**Preliminary Drainage Report
Meadow Lake Industrial Phase 1
El Paso County, Colorado**

HR Green Project No: 2202774

PCD File No. SP236

DRAINAGE MAPS
 PROPOSED DRAINAGE MAP

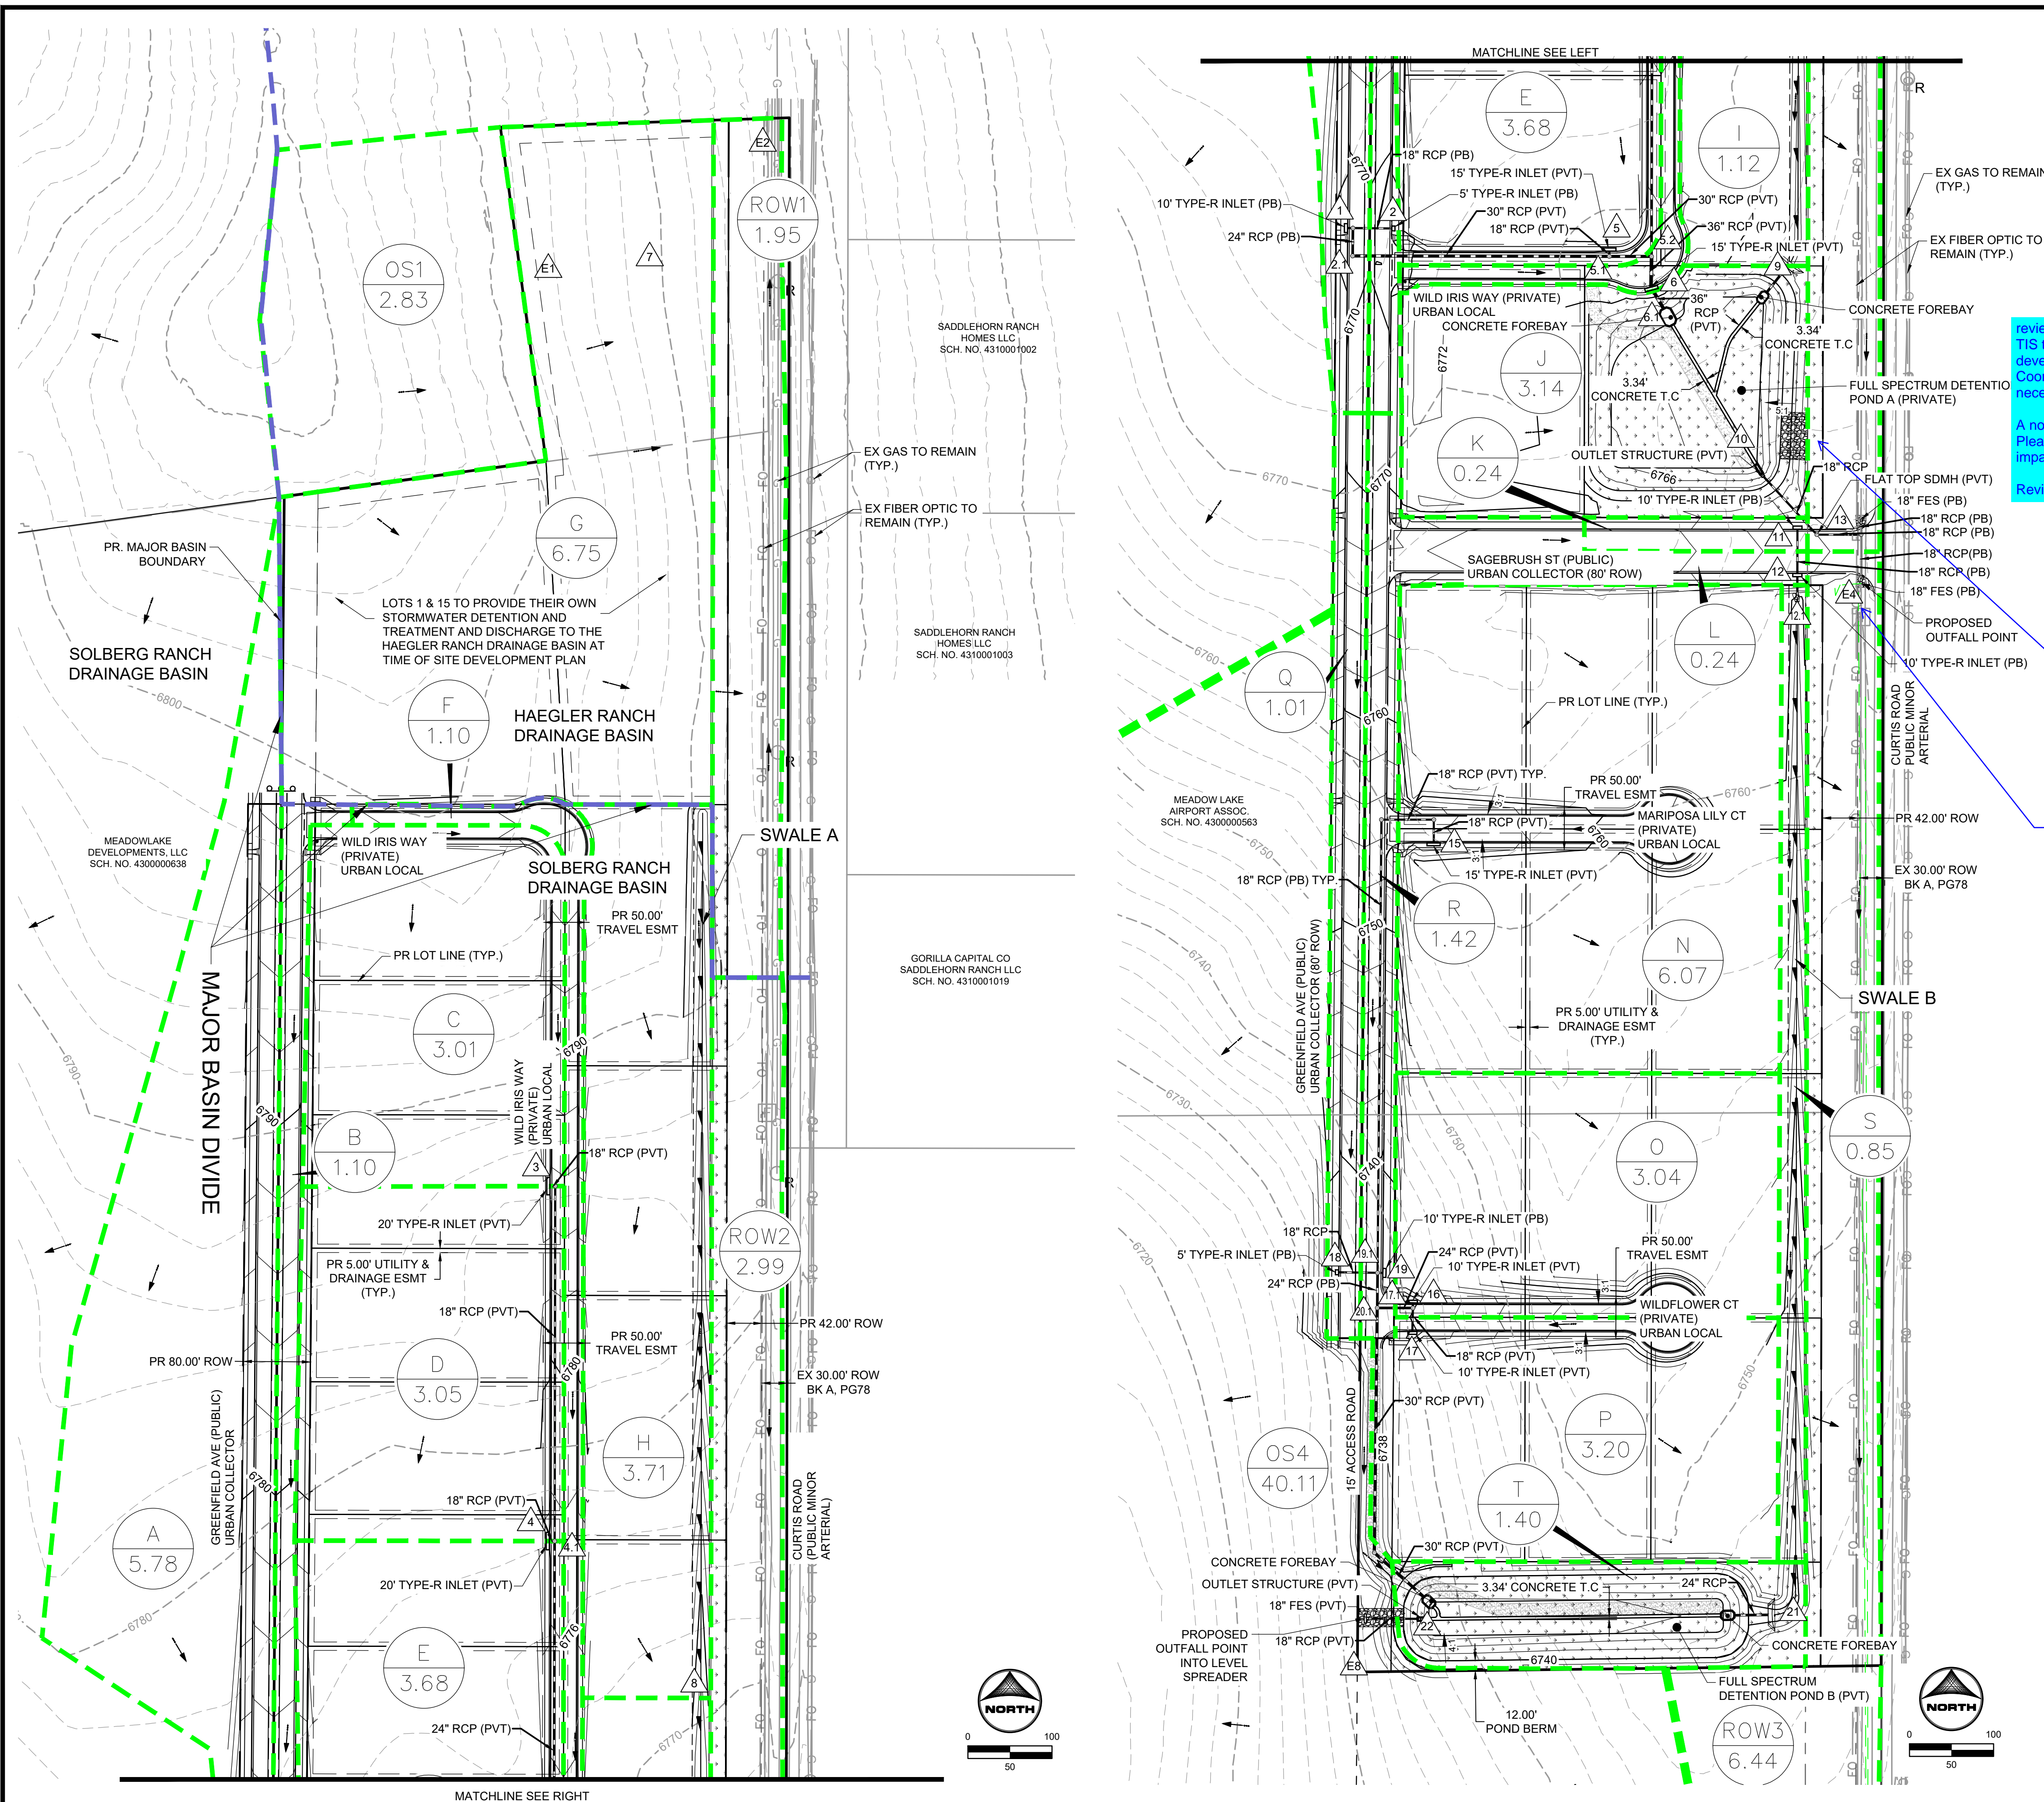
review 1 comment: comments have been provided on the TIS to identify improvements that may be needed with this development to Curtis Rd roadway cross section. Coordinate with the traffic engineer and account for any necessary improvements in your design.

Review 2: unresolved. Please address the above comment.

see comment in the narrative regarding the pond outfall to the ditch. Identify that roadside ditch will be analyzed/analyzed with the final drainage report to ensure a suitable outfall

Added required improvements and included in drainage analysis.

Identified in the report text (added statement in this edb's section.)
